PL202100191

CLOVER MALL  
BLOOMINGTON, MN

20 JULY 2021

1

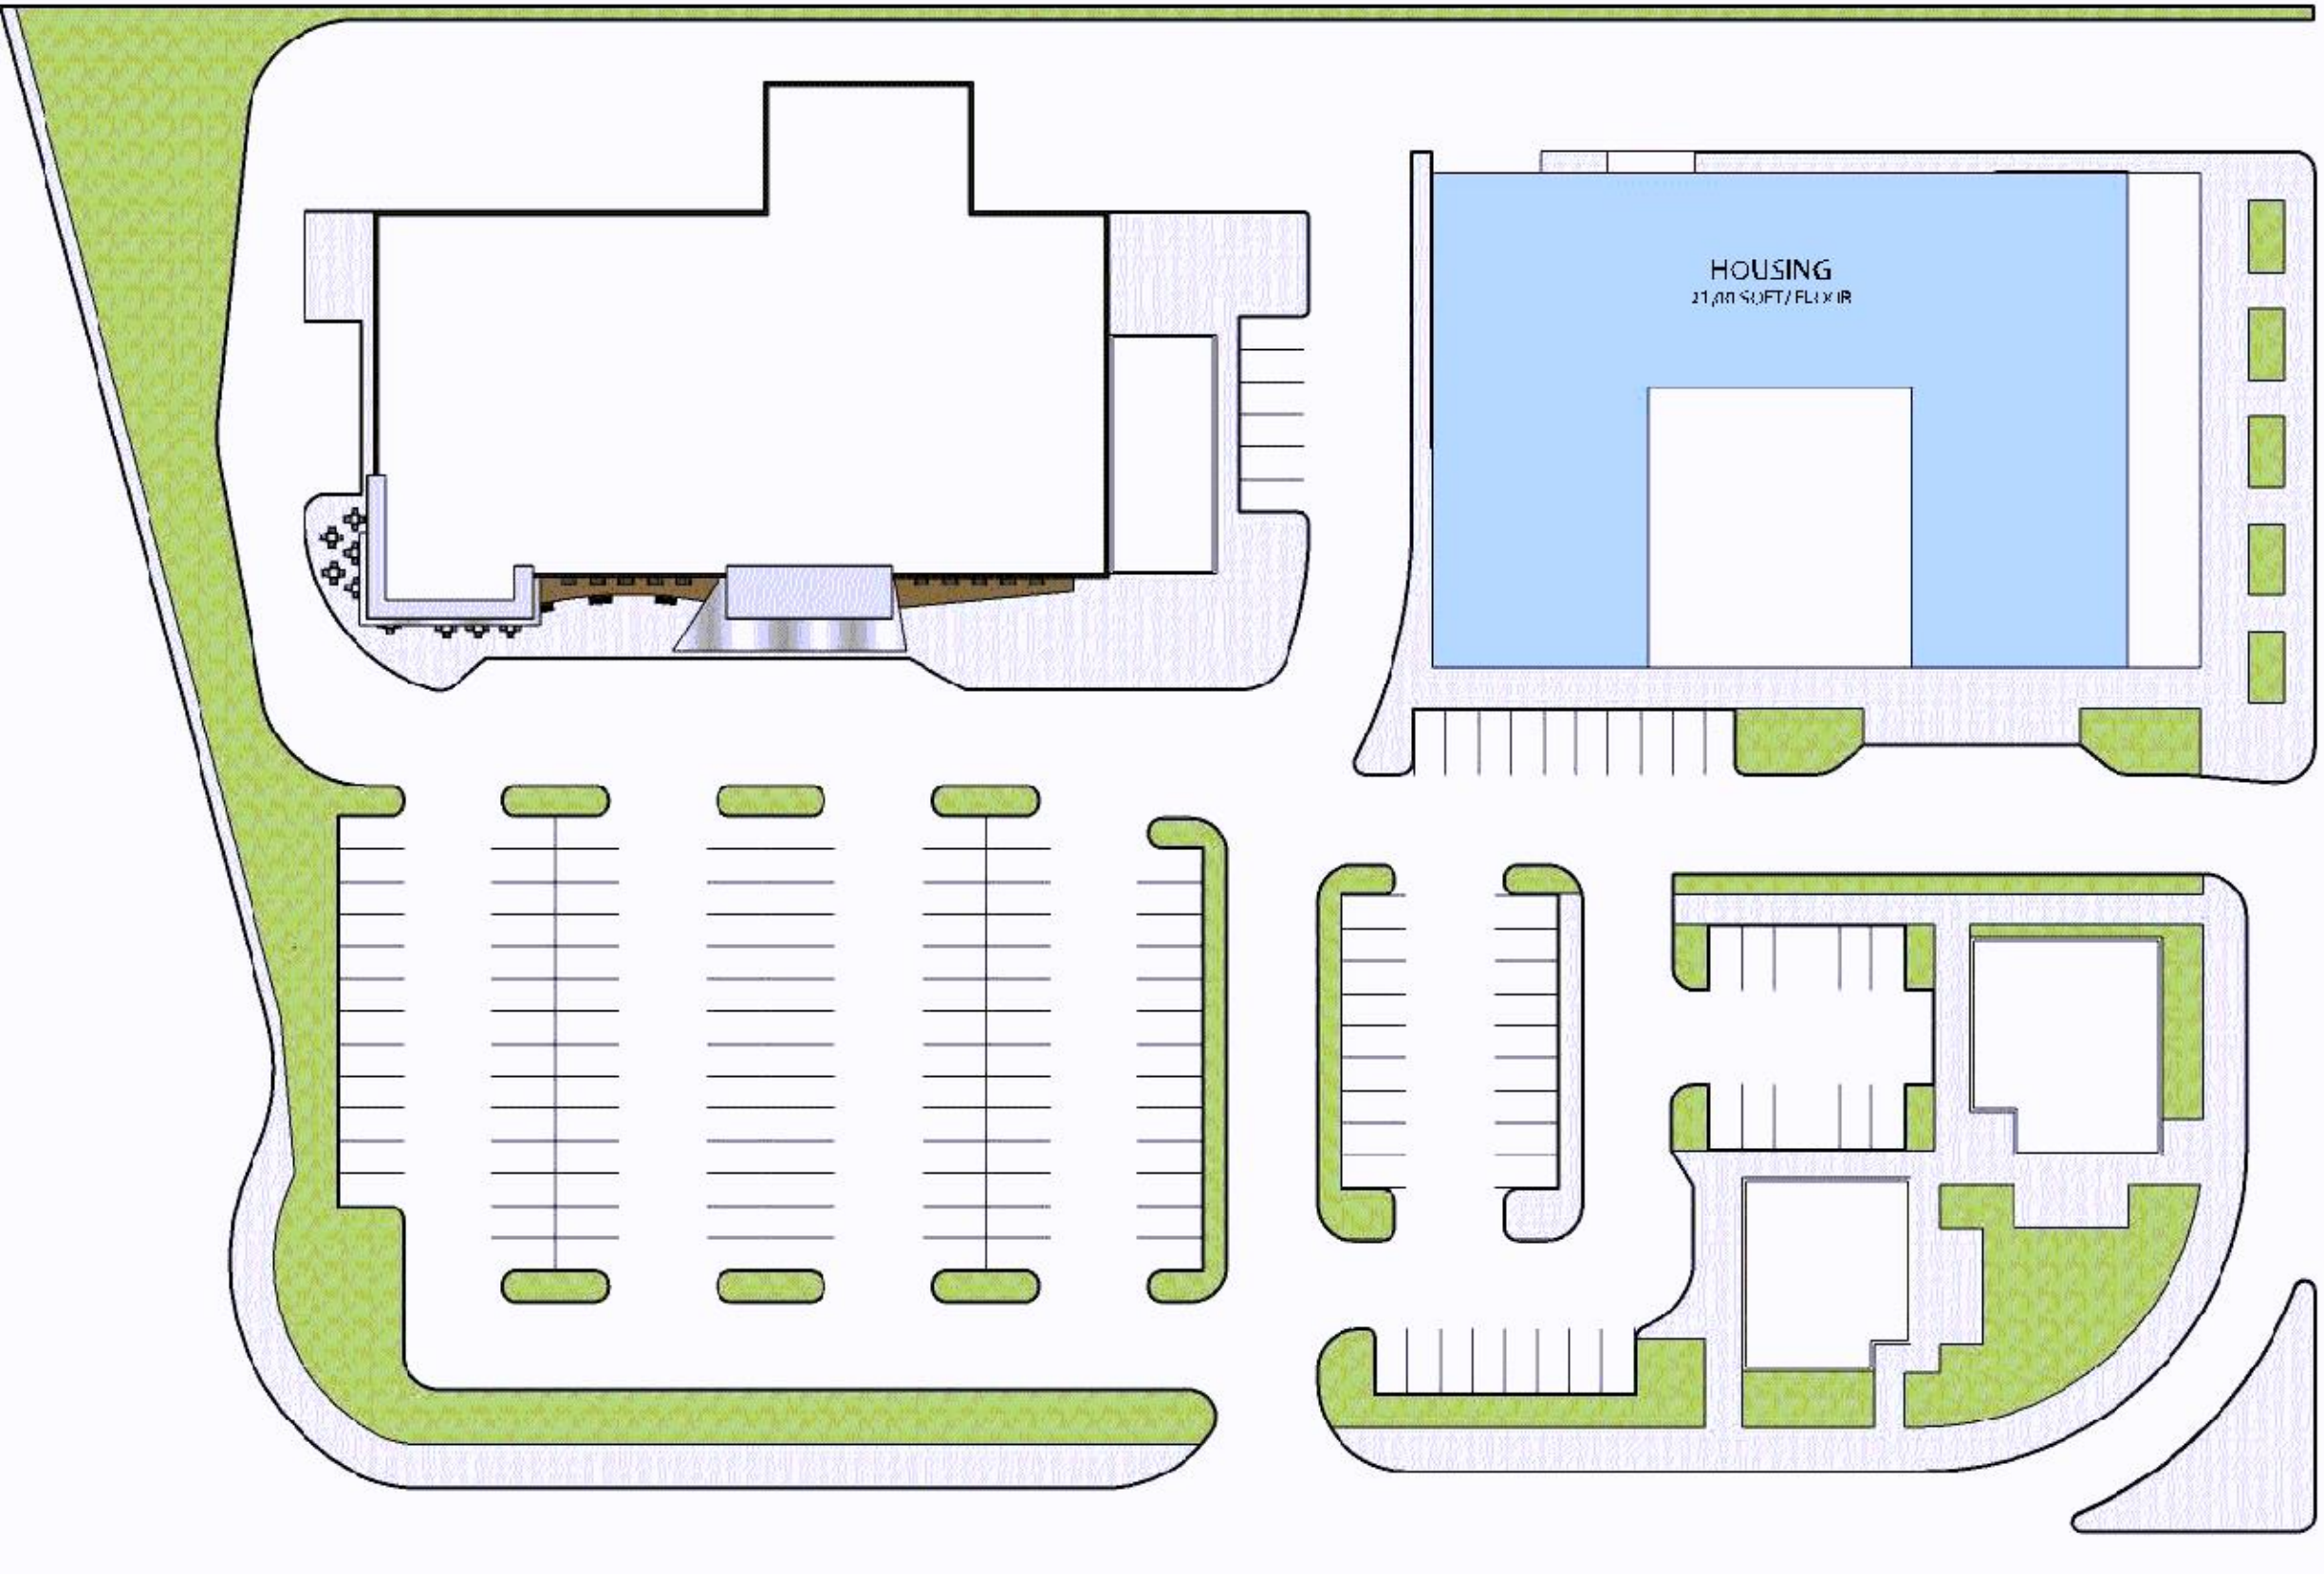
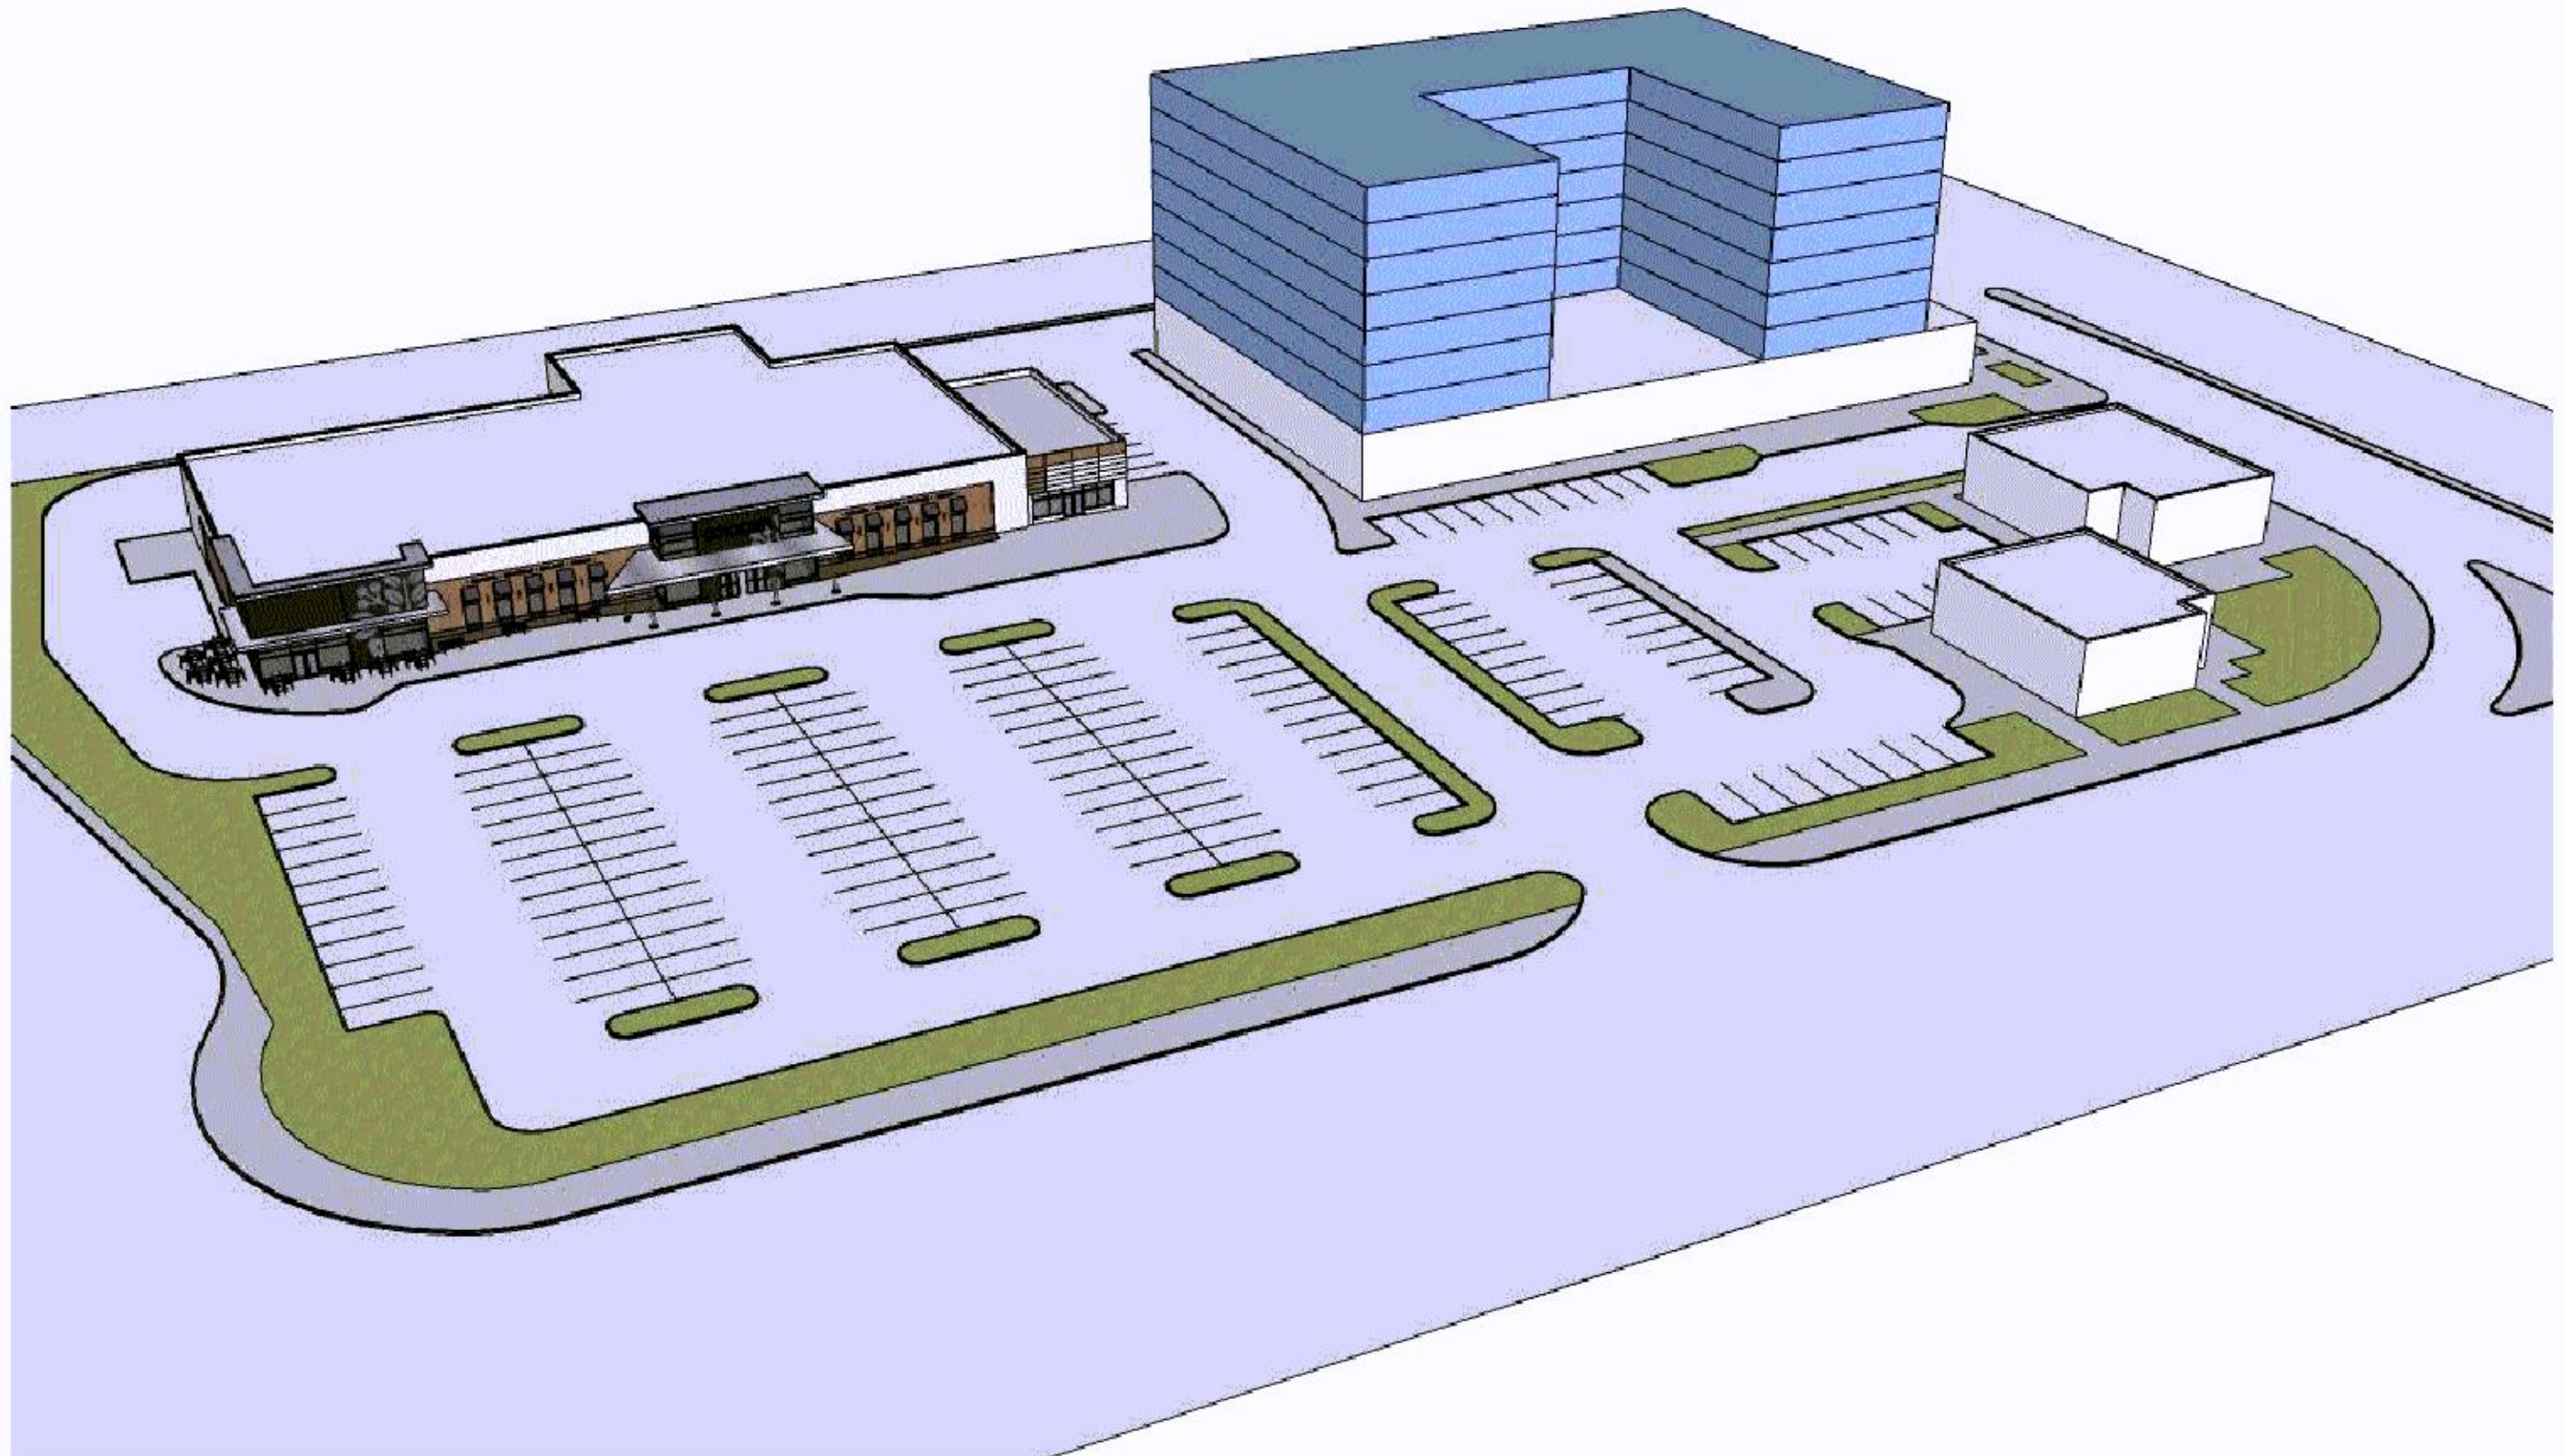
Revise sheet 1 of the  
preliminary development plan  
so the grocery building  
footprint, parking lot design,  
and pedestrian connection for  
the grocery are consistent with  
civil plans.

The square footages  
in the preliminary  
development plan are  
inconsistent with the  
rest of the plan set.  
Amend accordingly

Neither of the future retail  
buildings in the southeast  
corner of the site meet the  
minimum 4,000 square foot  
size requirement. Adjust the  
building size to 4,000 square  
feet. Alternatively, request a  
deviation for the future  
phase and detail how the  
corner and the two buildings  
could be designed to have a  
unified street presence.

Please adjust this page in the preliminary development plan. There are some minor inconsistencies.
